ITEM: 6.7	REPORT SUMMARY MINOR VARIANCE APPLICATION FILE NUMBER A076/25
-----------	---------------------------------------------------------------------

MINOR VARIANCE APPLICATION FILE NUMBER A076/25 16 Dew Drop Ct Maple ON L6A 1E8
-----------------------------------------------------------------------------------	-----------------------------------------------------------------------------------------------------------

PROJECT:	
Prop'd Pool	
16 Dew Drop Court	
Vaughan	
DRAWING:	
Site Plan	
PLOTTED:	
DATE:	PROJECT No.
2025-05-27	
SCALE:	DRAWING No.
AS NOTED	
DRAWN BY:	REVIEWED BY:

A2

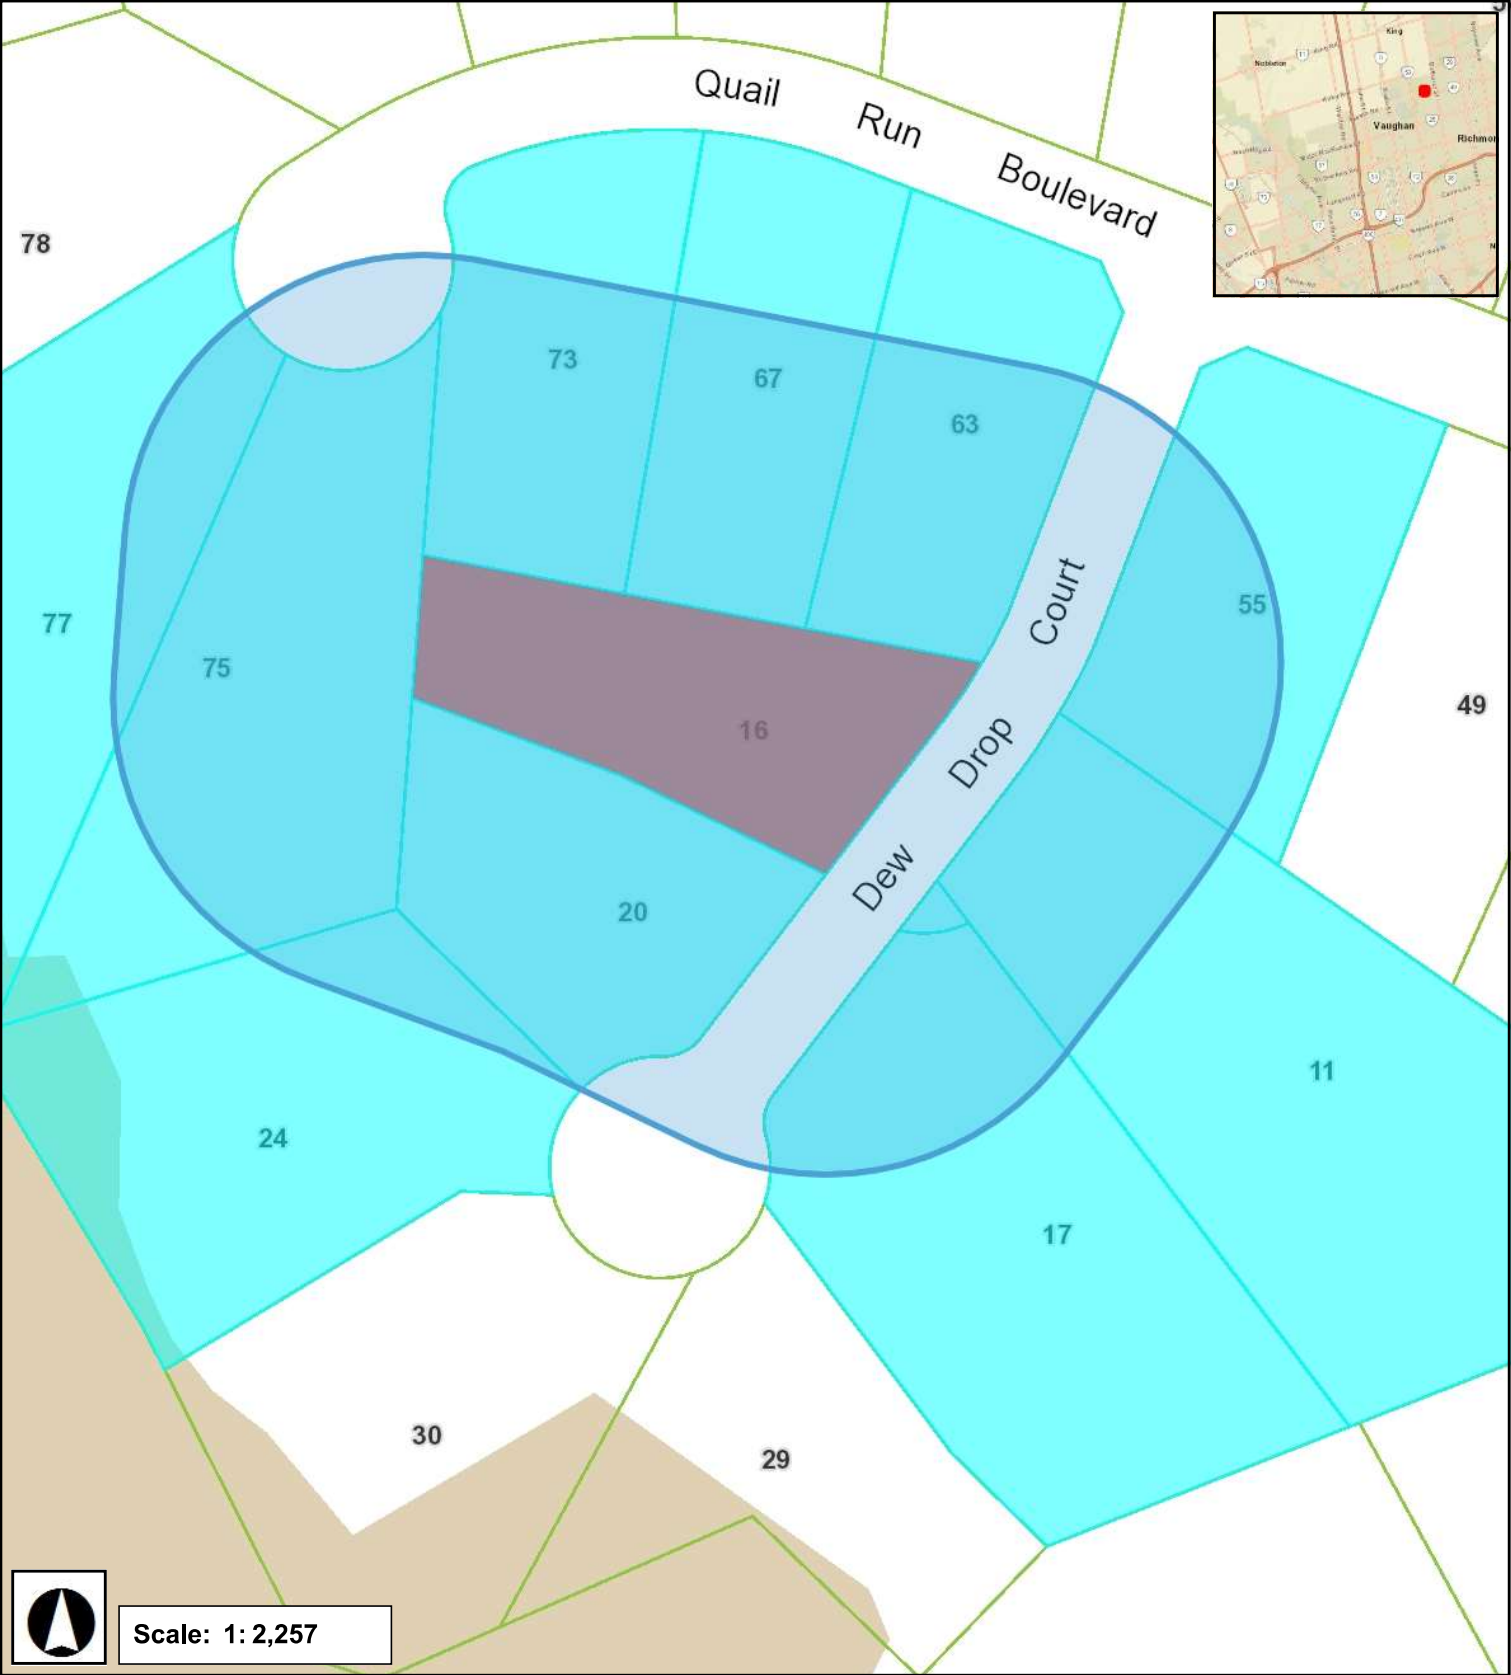
Zoning By-law 01-2021	
1	Applicant has indicated the “box” will not be provided and all equipment is open and unenclosed. The “box” reference should be removed from the site plan.

The Development and Parks Planning Department has no objection to Variance 1 to permit a maximum encroachment of 3.5 m for a heat pump, condenser or similar equipment (ground mounted) into a minimum interior side yard, whereas the Zoning By-law permits a 1.0 m encroachment. Due to the angle of the southerly interior side lot line, relief is required for the location of the existing pool equipment. The pool equipment is fully unenclosed and is not anticipated to cause adverse massing impacts to the abutting property. The Development Engineering Department has reviewed this application and have no objection.
